HISTORIC AND DESIGN REVIEW COMMISSION

HDRC CASE NO: 2023-029
ADDRESS: 1315 MARCH AVE
LEGAL DESCRIPTION: NCB 11176 BLK LOT 14 & 15
ZONING: I-1, H
CITY COUNCIL DIST.: 3
DISTRICT: Mission Historic District
APPLICANT: Gerardo Noriega/GNA Architecture
OWNER: Joe Sanchez/J SANCHEZ CONTRACTING INC
TYPE OF WORK: Front yard fence, driveway widening, and sliding driveway gate installation
APPLICATION RECEIVED: January 11, 2023
60-DAY REVIEW: Not applicable due to City Council Emergency Orders
CASE MANAGER: Claudia Espinosa

NEW FENCE & GATES
1315 MARCH AVE

03 TYPICAL FENCE ELEVATION
1/2" = 1'-0"

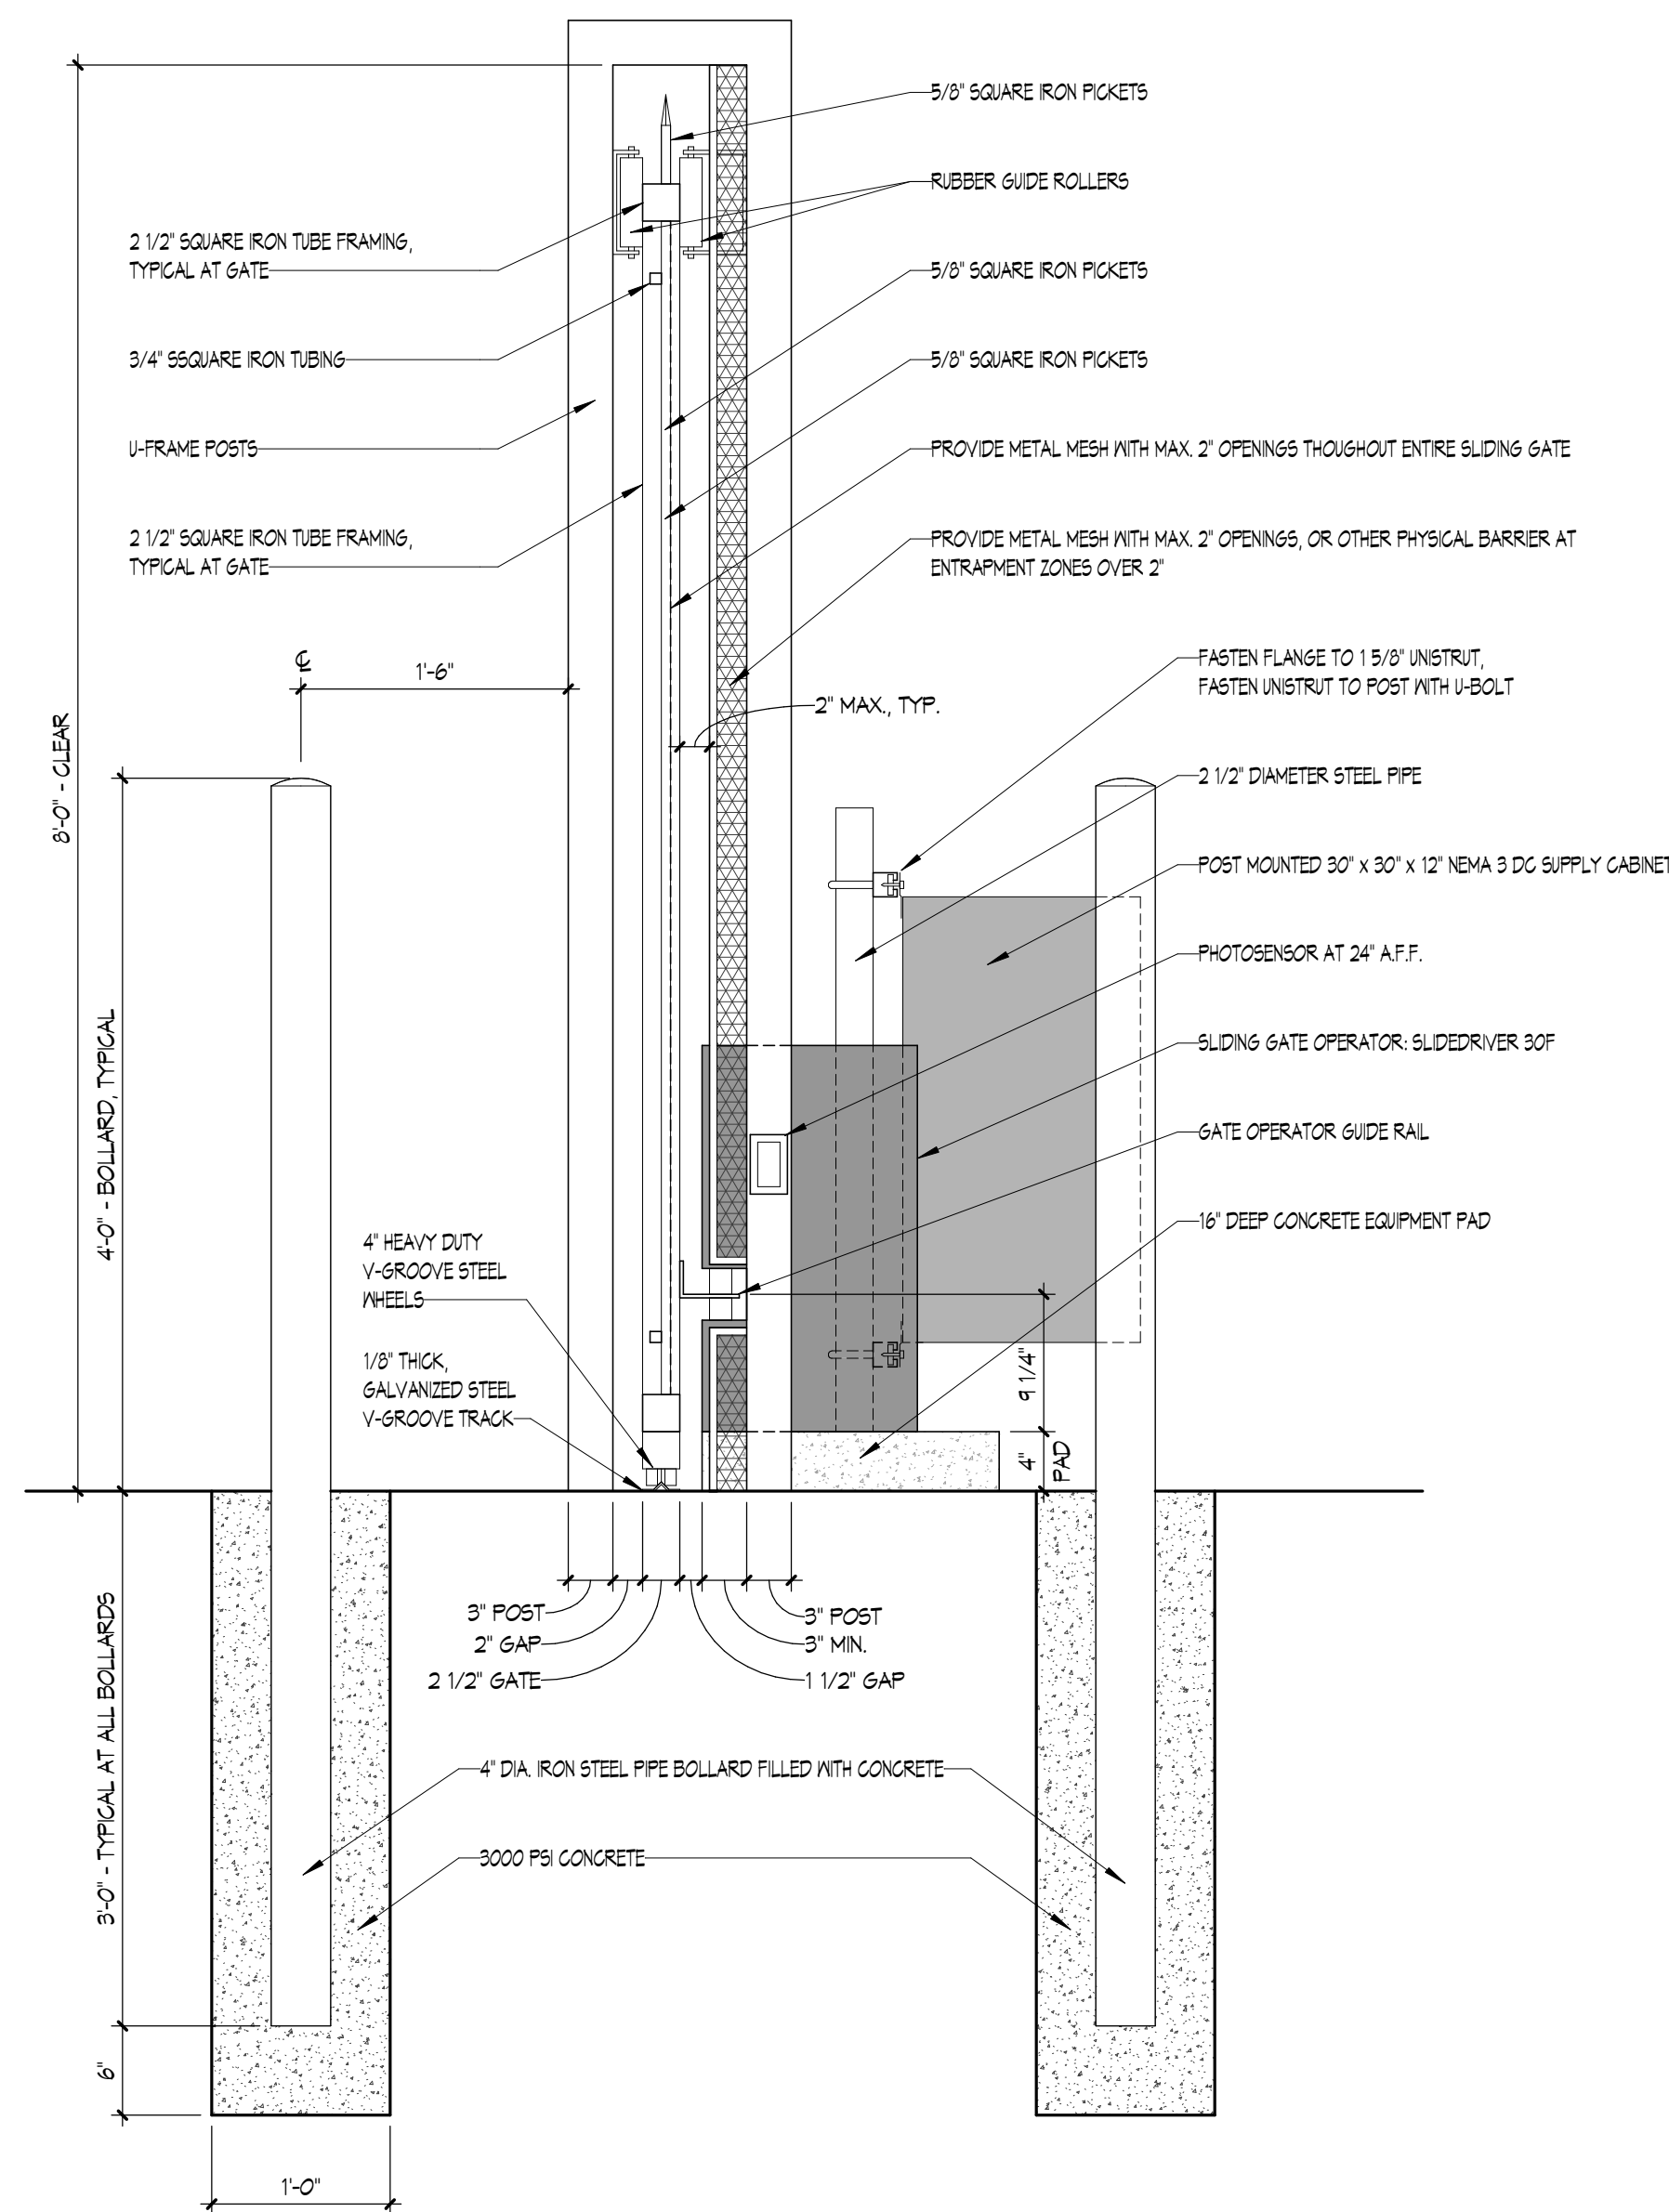
- d. DRIVEWAY GATE INSTALLATION – The applicant has proposed to install a metal sliding driveway gate measuring eight (8) feet in height to meet the existing neighboring fencing meeting at the property line. The Guidelines for Site Elements 2.B.iii, limit the height of new fences and walls within the front yard to a maximum of four feet. The appropriateness of a front yard fence is dependent on conditions within a specific historic district. New front yard fences should not be introduced within historic districts that have not historically had them. If a taller fence or wall existed historically, additional height may be considered. Due to the atypical fencing height in the district, staff finds the request to be appropriate with the maximum height being six (6) feet.

- e. FENCE DESIGN – The applicant has proposed to install a wrought iron fence, matching the fence design in the submitted example photo. Per the Guidelines for Site Elements B. i. new fences and walls should appear similar to those used historically within the district in terms of their scale, transparency, and character. Design of fence should respond to the design and materials of the house or main structure. Staff finds this request should include the a maximum hieght of six (6) feet and the mesh to be only included on the motorized portion of the gate.

Staff recommends approval of item 1, the removal of the existing chain link fence and replace it with a new wrought iron fence with a maximum height of six (6) feet and a motorized sliding gate based on finding d and e. With the stipulation that the metal mesh be only installed on the motorized portion of the wrought iron fence.
